CITY OF ALBUQUERQUE

Re: Sony Imageworks Grading and Drainage Plan
Engineer's Stamp dated 5-8-08 (R16/DA3006)

Re: Sony Imageworks Grading and Drainage
Plan Engineer's Stamp dated 5-8-08 (R16/DA3006)

Sony Imageworks-Shell
@Mesa del Sol
5640 University Blvd SE
Albuquerque, NM 87119

Add Drainage Control Berm

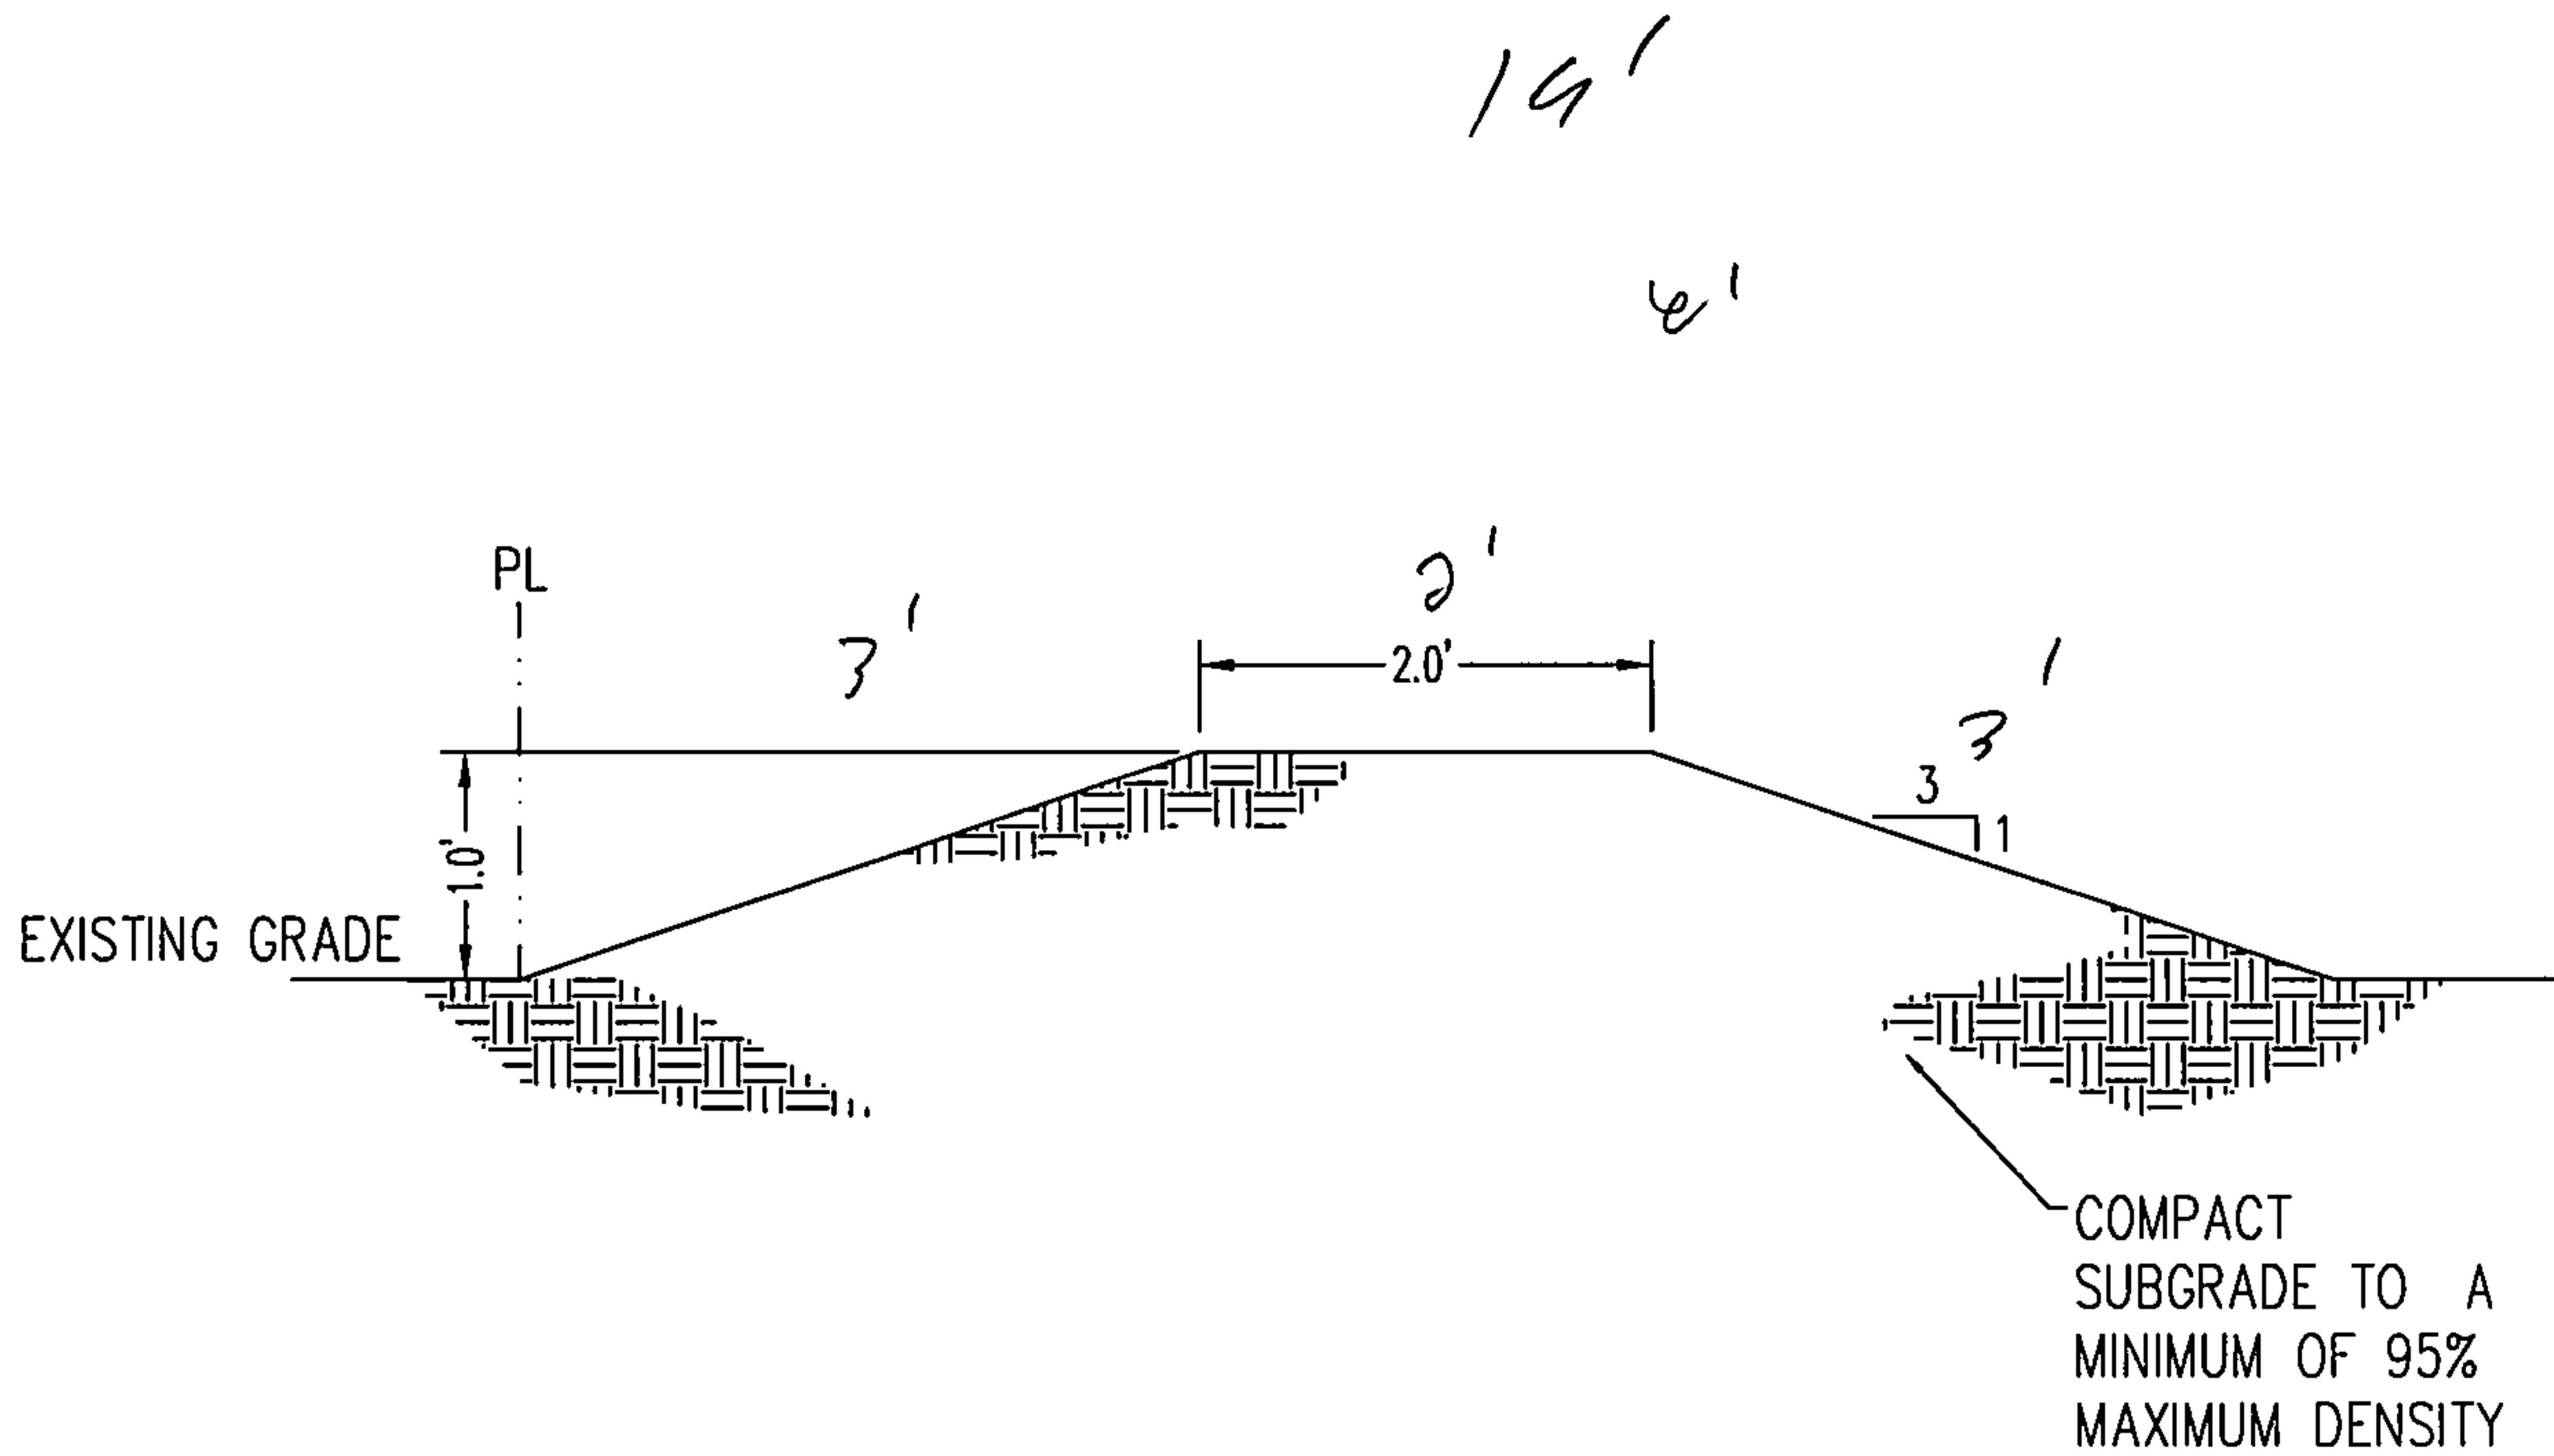
'It appears that run-off from the northeast portion of the future parking area will leave the site. A berm may be required along the rear property line to prevent run-off from leaving the site.'

- It appears that runoff from the northeast portion of the future parking area will leave the site. A berm may be required along the rear property line to prevent runoff from leaving this site.

With this letter, we have provided a detail of the drainage control berm that we will issue to the contractor.

18. INSTALL DRAINAGE CONTROL BERM 1' ABOVE FINISHED GRADE, PER DETAIL SHEET 1.1
